H TECHNICAL BULLETIN

HT230 TRAILER AIR SUSPENSION QUIK ALIGN? RETROFIT

No: TRAILER AUS-003
Subject: *Installation Instruction*
Date: November 1999 Revision: 2

Figure 1

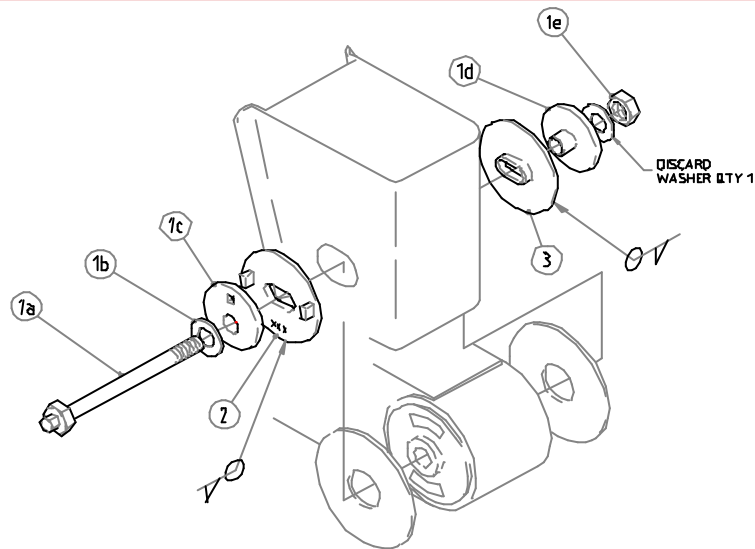
An outboard, adjustable eccentric (item 1b) replaces the welded alignment collar at the Tri-Functional Bushing pivot connection. Rotating the eccentric adjusts the axle, fore and aft, in a straight line.

The pivot connection is clamped together with a shear head bolt which eliminates the need for a torque wrench because the head shears off at 550 ft-lbs (refer bulletin AUS-015).

The Quik-Align™ retrofit kit, part number 98690-001 allows previous model HT230 and HT250 series suspensions to be updated to incorporate these features.

5. Insert items 2 and 3 into the hanger as in *Figure 1*. Ensure item 2 is orientated with the part number to the bottom and located outboard of the hanger. Assemble the remaining kit components as shown and tighten the pivot bolt until it contacts the washer/flange adaptors however do not torque the bolt.

Note: *Discard one of the 7/8" hardened flat washers from the hardware kit as shown in Figure 1.*

7. Weld the adaptors to the hangers as specified in *Figure 1*.
8. Remove the pivot bolt and eccentric (items 1) and allow the welded adaptors to air cool.
9. Paint all effected areas to the trailer specification.
10. Assemble the suspension beam, thrust washers and remaining **Quik-Align™** kit as shown. Do not torque the pivot bolt.

Note: *Ensure that the pivot bolt head and the eccentric flanged washer are outboard with the square adjusting hole at the 12 o'clock position.*
